# FAIRFAX COUNTY

## STAFF REPORT ADDENDUM II

RZ/FDP 2001-PR-050

**APPLICANT:** Stanley-Martin Homebuilding, LLC

LANDSCAPE AND TYPICAL LOT DETAILS

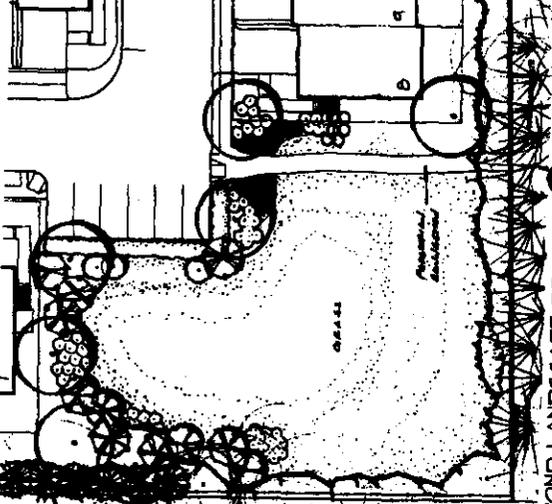
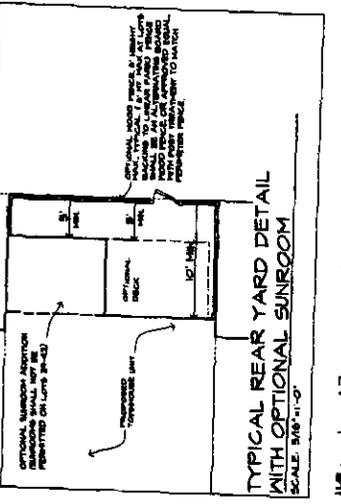
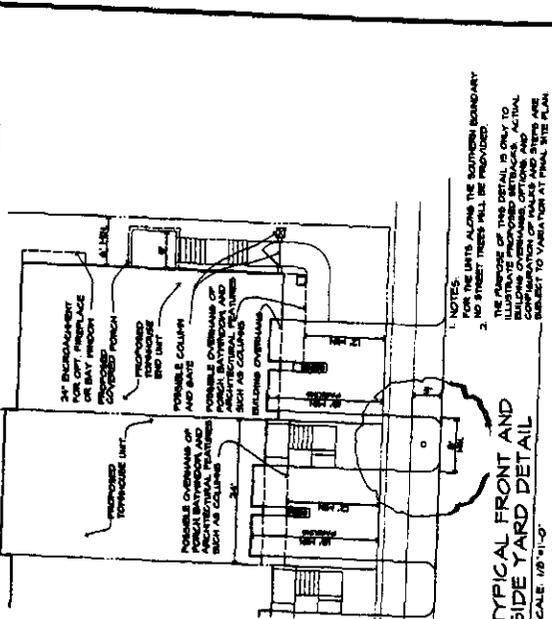
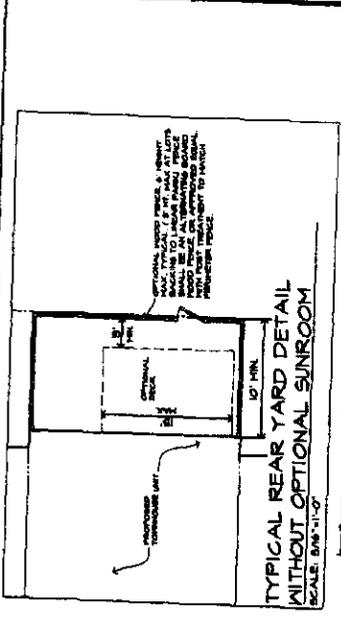
**Typical Yard Details:** Sheet 5 contains three typical yard details. The first detail depicts the rear yard with the optional sunroom. Detail 1 notes that the optional sunroom will be no closer than five (5) feet to the rear lot line. Furthermore, if a deck is added to a unit with a sunroom, the deck will be no closer than five (5) feet to the rear lot line. The second detail depicts the rear yard without a sunroom. Detail 2 indicates that the deck on a unit without a sunroom can be located three (3) feet from the rear lot line. In addition, the deck can be no wider than 15 feet. This restriction is also included in the proffers (Proffer 15). Finally, the last detail provides the typical for the front and side yards of units. Detail 3 notes that the driveways will be at least 18 feet long but that there could be a possible second story building overhang over the driveway. The side yards will be at least six (6) feet wide. However, there could be an encroachment into this yard for a fireplace, bay window,

staircase and covered porch. It should be noted that this encroachment cannot be any greater than three (3) feet per the Fire Marshal.

**ARCHITECTURAL ELEVATIONS**

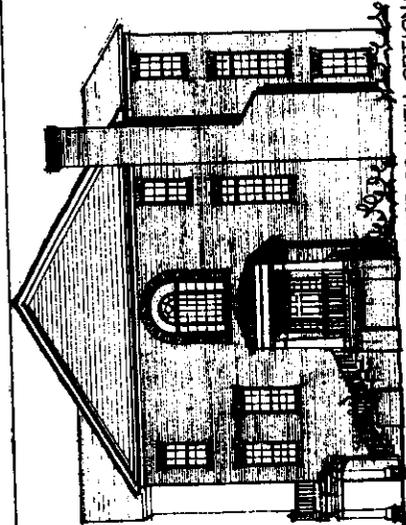
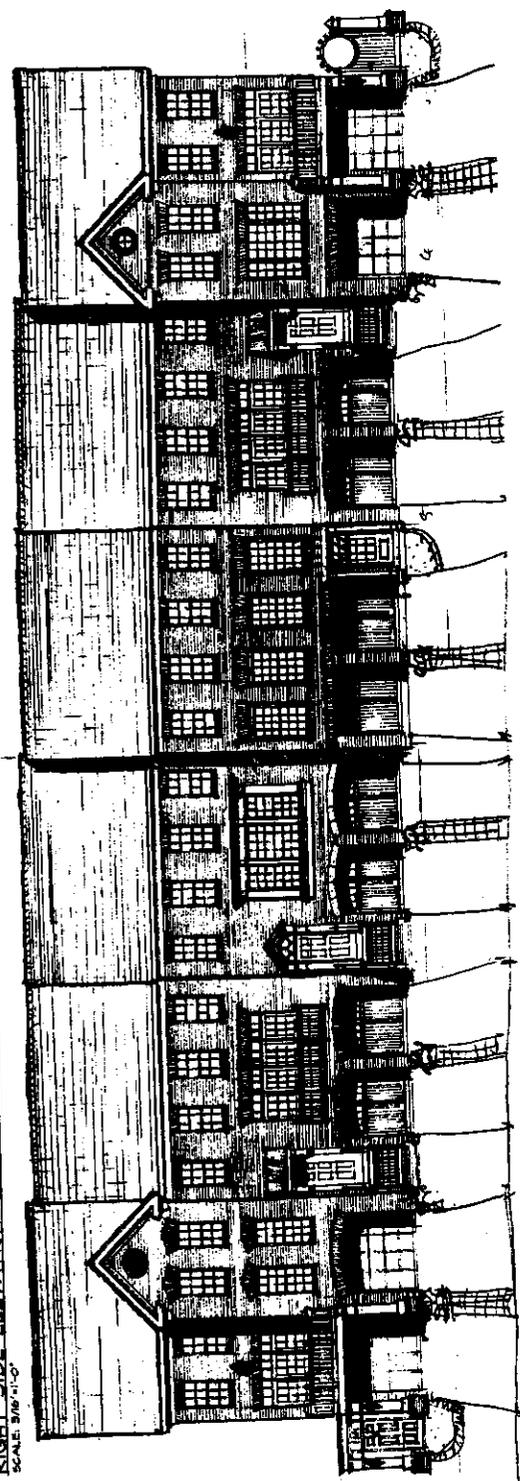
Subsequent to the publication of the Staff Report, a revised Conceptual/Final Development Plan (CDP/FDP) was submitted, which included two changes. First, new architectural elevations were proposed. Second, the distance between the optional sunroom and the southern and eastern periphery of the site was increased from 20 to 25 feet. An addendum to the Staff Report was published on May 29, 2002. In this addendum, staff continued to recommend approval of RZ 2001-PR-050 and the Conceptual Development Plan subject to the execution of proffers consistent with those dated May 23, 2002. Staff also recommended that FDP 2001-PR-050 be approved subject to the proposed development conditions dated May 1, 2002, and the Board's approval of RZ 2001-PR-050 and the Conceptual Development Plan.

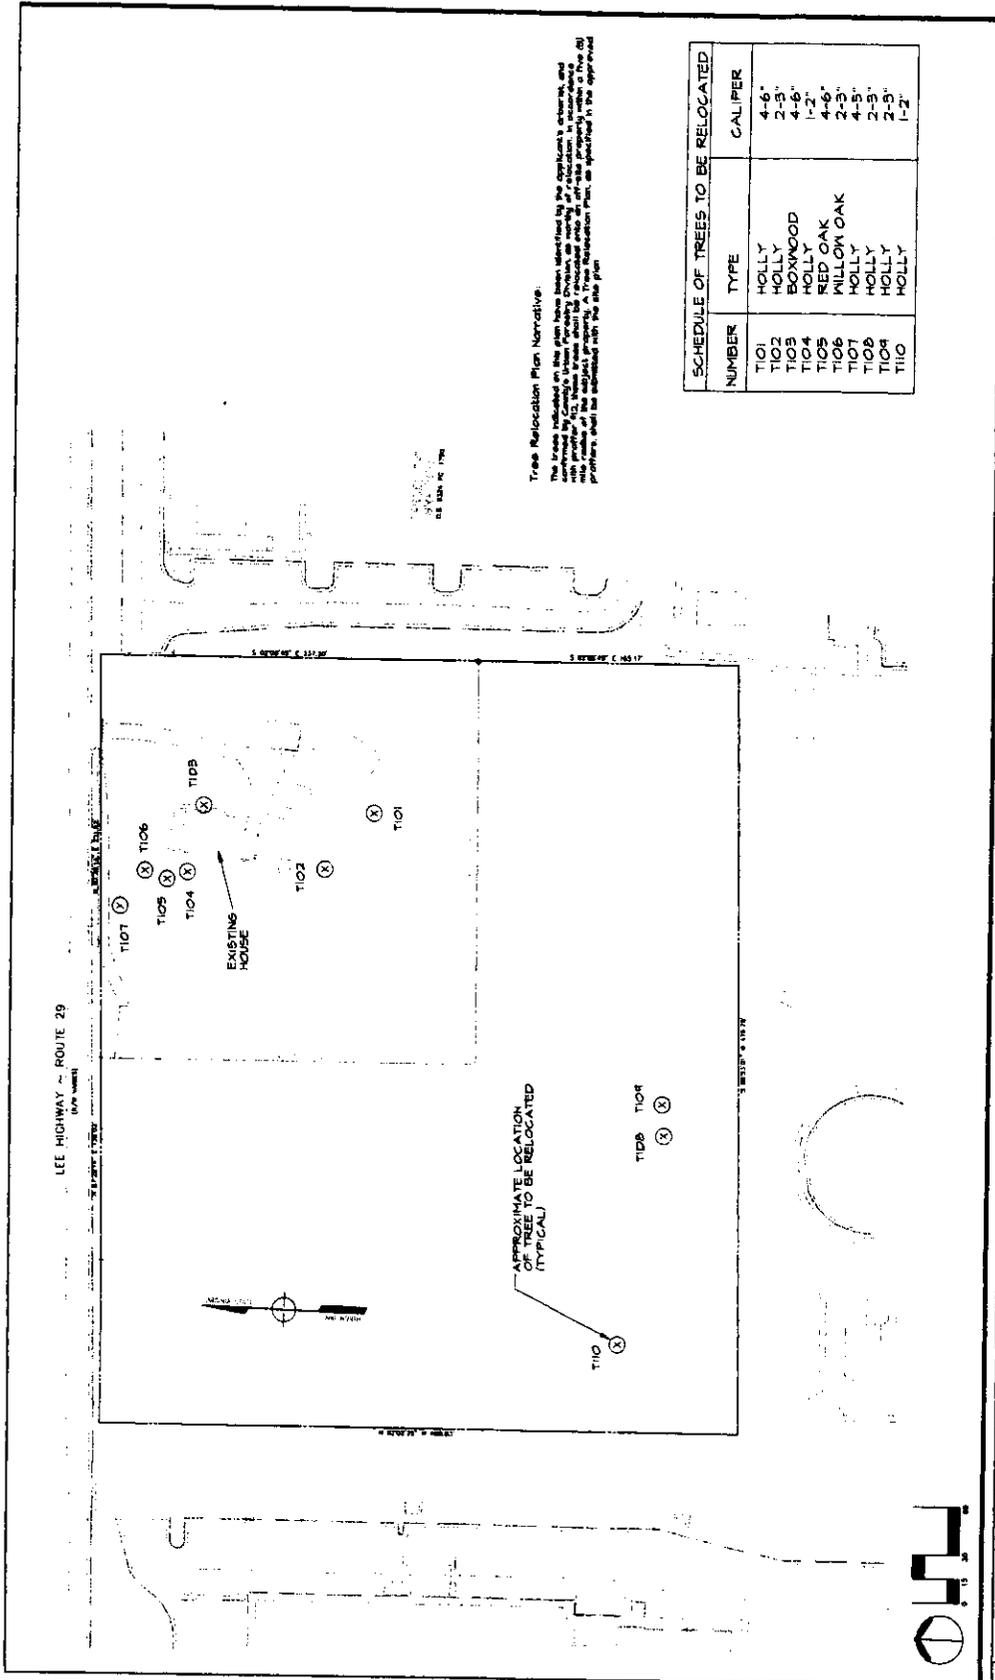
**Tree Relocation Plan:** A new sheet has been added (Sheet 7) which depicts the location of the proposed trees to be relocated under the applicant's tree location plan.

12. **Tree Relocation Plan.** The Applicant shall prepare and implement a tree relocation plan to transfer certain holly trees, as specified on Sheet 7 5 of the CDP/FDP, onto an off-site property within a five (5) mile radius of the Subject Property; the off-site location to be subject to the approval of the Urban Forestry Division and the owner of the recipient off-site property. This plan shall be submitted with the construction plans for the subdivision. Specifically, existing holly trees worthy of transplantation, as identified by the Applicant's arborist on a tree relocation plan, shall be relocated from the on-site areas to the recipient off-site property. The following components shall be included in the relocation plan: identification of the existing locations of the trees to be relocated; an assessment of the condition and survival potential of said trees; the proposed location receiving said trees; the timing of relocation in the development process (the tree relocations shall occur at the start of site development work as approved by the receiving property owners and the County Urban Forester); the proposed time of year of the relocation; the relocation methods to be used, including tree spade size if one is used; the relocation site preparation materials and methods; and initial care after transplanting, including mulching and watering specifications to be conducted. Said plan shall be subject to review and approval of the Urban Forestry Division and shall be implemented by the Applicant.
